ADDENDUM NO. #0

TRACK & FIELD IMPROVEMENTS

Rio Mesa High School

April 10, 2020

SHEET NUMBER
L1.0 **AD0-L1**

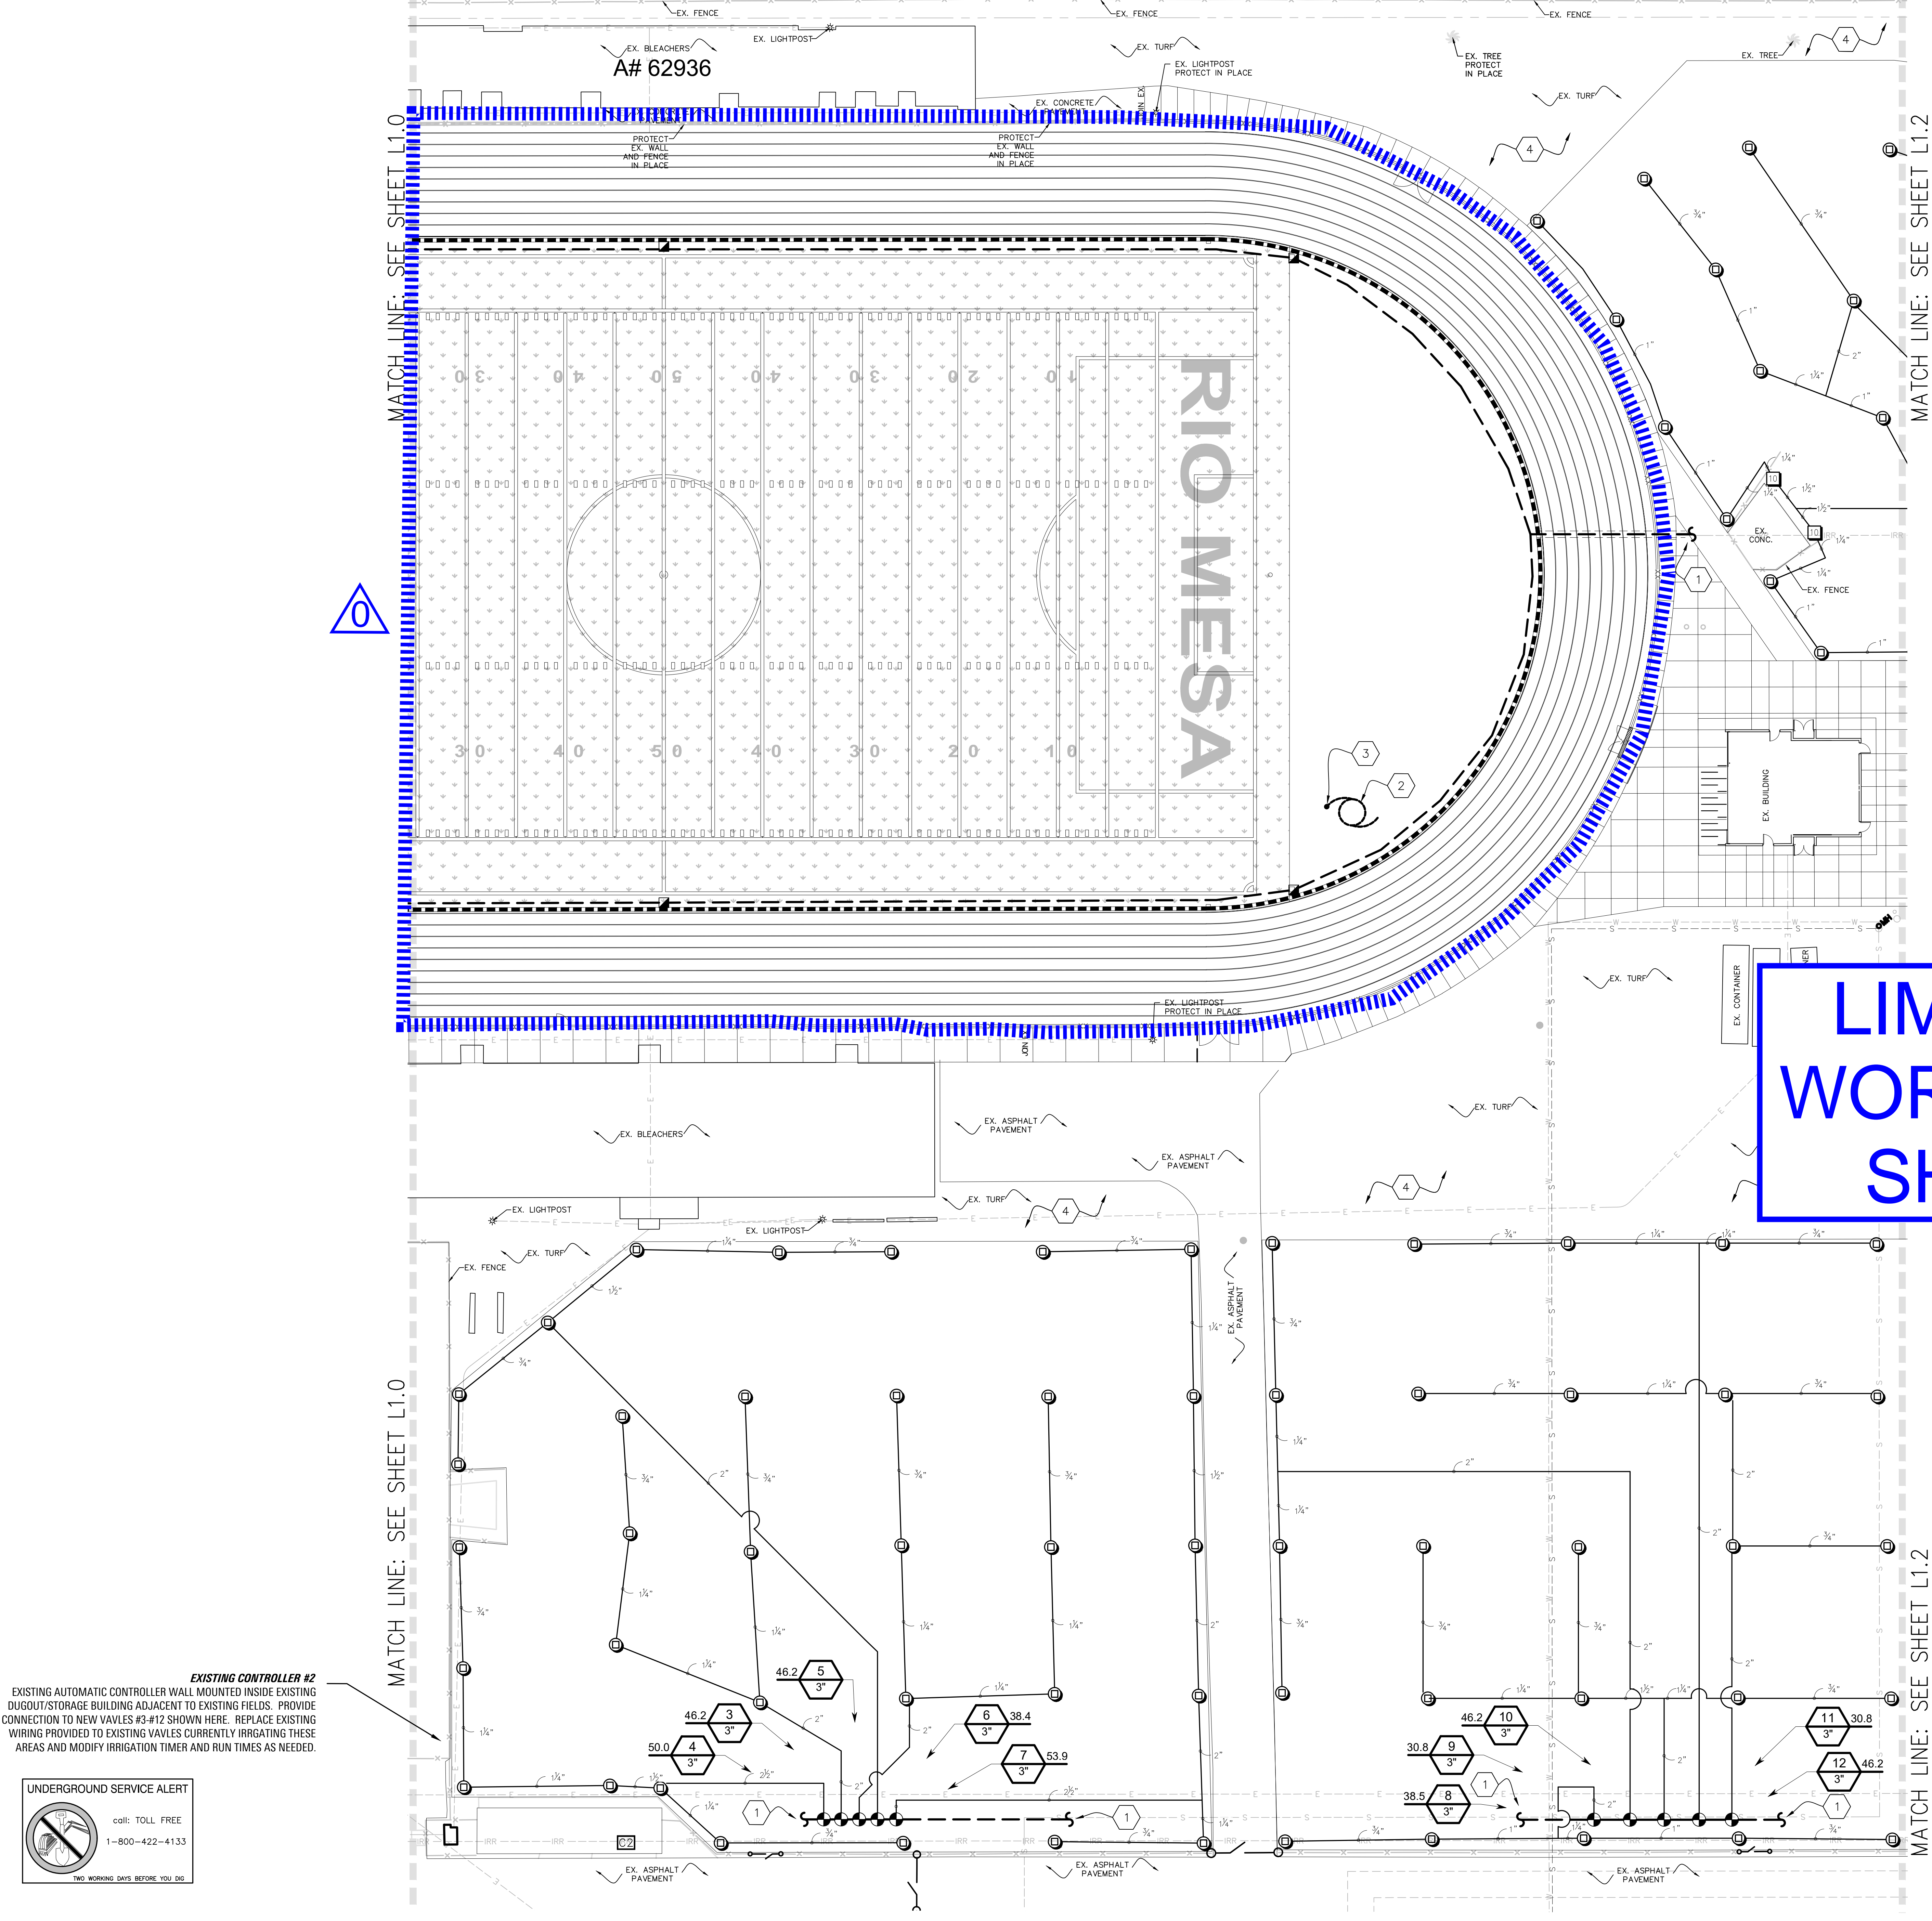
- 3.2.2.1.** Drawing L1.0/AD0-L1 - Area of work has been revised as shown on this sheet. Irrigation valve #1 will need to be installed within the revised work area and connected to bubbler system for palm trees in this phase. Mainline and Laterals to be stubbed out for future connection.

VALVE #1 TO BE INSTALLED
ADJACENT TO VALVE #2 AND
CONNECT TO (9) PALMS IN THIS
PHASE. CAP LATERAL AND MAIN
FOR FUTURE CONNECTION.
